EMANUELLI COURT SUBDIVISION

Engineering Comments: FINAL PLAT COMMENTS (should be addressed prior to submitting the FINAL PLAT for review and/or signature by the City Engineer):

The plat illustrates the proposed 2-lot, 0.7±-acre subdivision located at the West side of Gulfwood Drive, 95'± South of the West terminus of Gulfwood Drive, in Council District 7. The applicant states the property is served by public water and sanitary sewer systems. The purpose of this application is to create two (2) legal lots of record from a single legal lot of record.

SITE PLAN

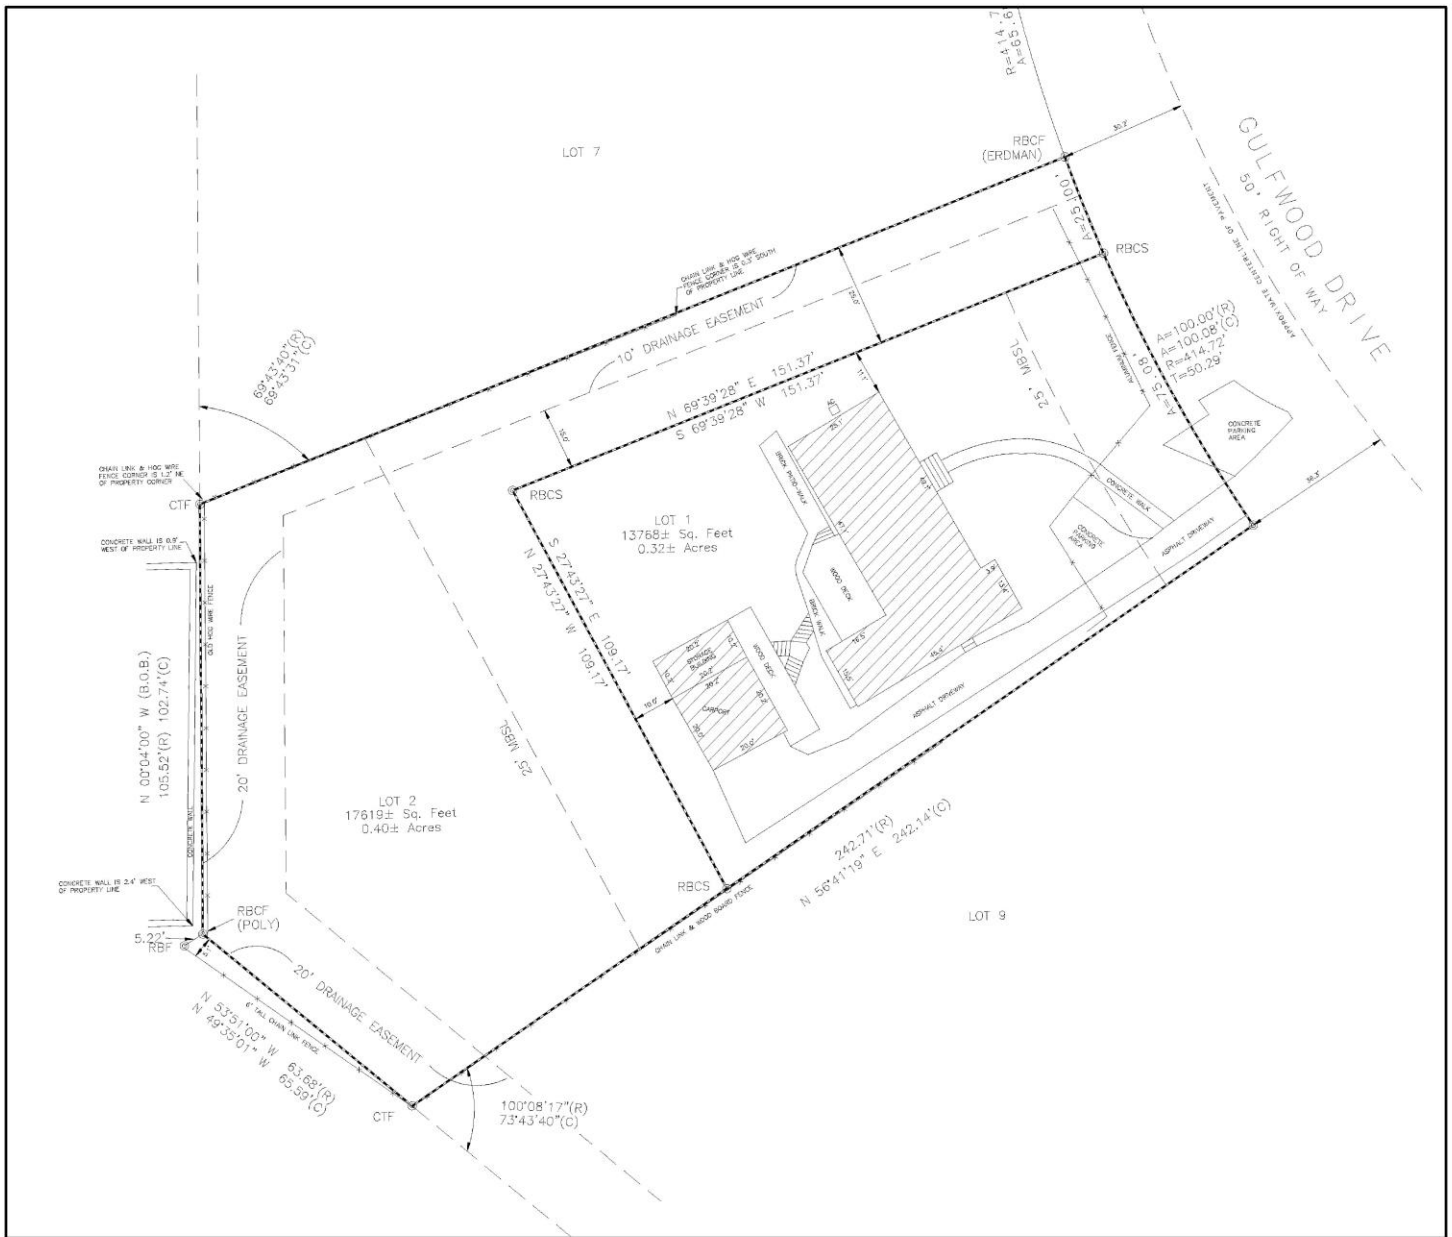
Proposed Lot 2 is irregularly shaped and may be regarded as a "flag" lot with a 25-foot wide "pole". Such a lot design is generally discouraged by Sections V.D.1. and V.D.2. of the Subdivision Regulations, the exception being the approval of lots located where varied and irregularly shaped lot designs are common, and the informality of design is consistent with other lots in the vicinity. The Planning Commission has not approved a similar design for any lots within the vicinity of the subject site, therefore approving the request may result in a subdivision that is out of character with the surrounding neighborhood.

The 25-foot minimum building setback line required by section V.D.9 of the Subdivision Regulations is illustrated along Gulfwood Drive, for Lot 1, and on Lot 2 where it is at least 60-feet wide. This information should be retained on the Final Plat, if approved.

Finally, a 10-foot drainage easement is illustrated along the North property line, and a 20-foot drainage easement is illustrated along the West property line. If approved, a note should be provided on the Final Plat stating no structure shall be constructed in any easement without permission of the easement holder.

- 1) approving the plat will not be compatible with Sections V.D.1. and V.D.2. of the Subdivision Regulations; and,
- 2) approving the plat will result in a subdivision whose design is out of character with the surrounding neighborhood.
